Regulations Nos. 37 (Filament lamps), 99 (Gas-discharge light sources) and 128 (Light emitting diodes light sources)

Proposal for Supplement 45 to the 03 series of amendments to Regulation No. 37 (Filament lamps)

Submitted by the expert from the International Automotive Lighting and Light Signalling Expert Group (GTB)*

Annex 1, Sheets H19, replace by new sheets, to read:

Figure 1
Main drawing

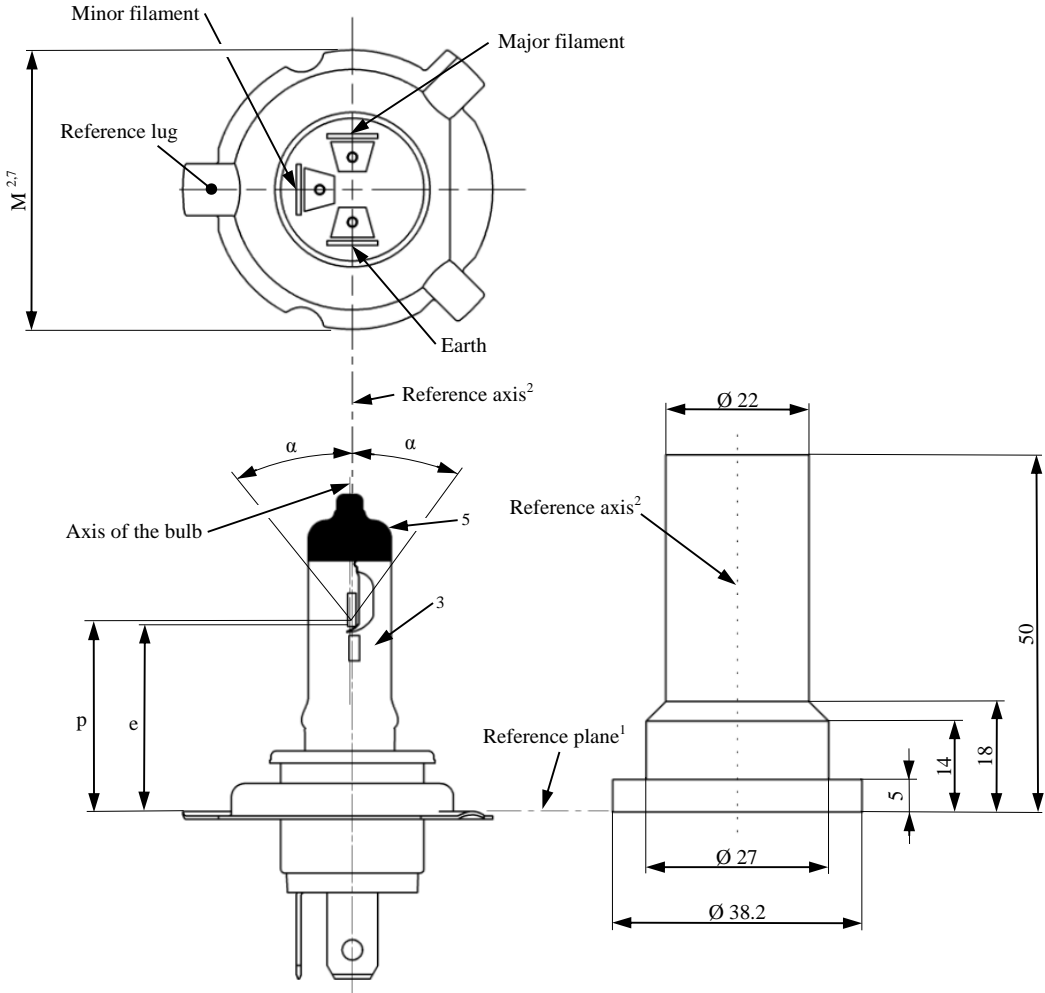
The text reproduced below was prepared by the expert from GTB to clarify the specifications of filament lamp category H19. The modifications to the existing text of the Regulation are marked in bold for new or strikethrough for deleted characters; modifications in the drawings are not marked.

2. The H19 sheets were refined by an improved description of the shield parameters (introduction of parameter “B”, tightened tolerance of parameter “q”) and of the relative position of the minor filament to the shield (modified measurement position for the parameters “b1”, “b2”, “c” and “h”). In addition, an editorial correction was made by exchanging the values of the tolerances of parameters “g” for the standard filament light source. These modifications are reflected in the drawings.
